Bulletin No 08-8

Product Bulletin

Product: CS1000 P4 Core Drill Rig
Area: **Wireline Winch c/w Levelwind 3760013369**

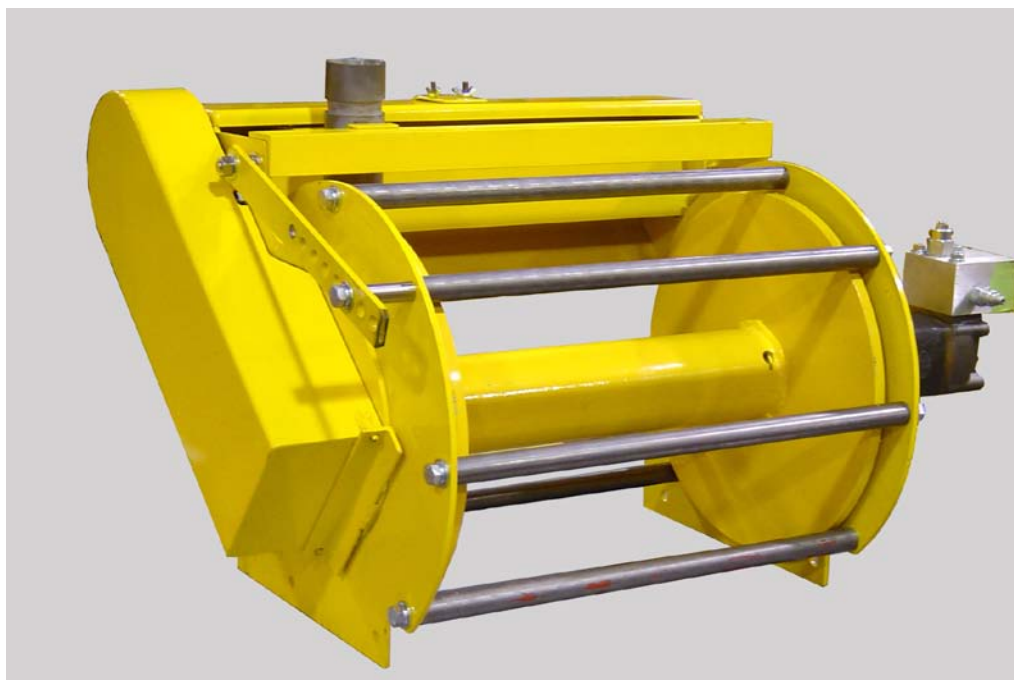
Atlas Copco Exploration Products is issuing this bulletin to notify customers that we have made available the following Levelwind option for our CS1000 P4, P6 and P6L Drill Rig. The part number for the **NEW** Levelwind would be **3760012319**.

Please note that if the customer wants to add the levelwind to an existing wireline winch, a modification to the existing wireline is needed. This modification requires drilling and tapping a hole into the drum shaft, and the installation of an adapter. A field kit for this procedure is available and would be supplied with the Levelwind. We are also able to supply the entire winch complete with the levelwind under part number 3760013369.
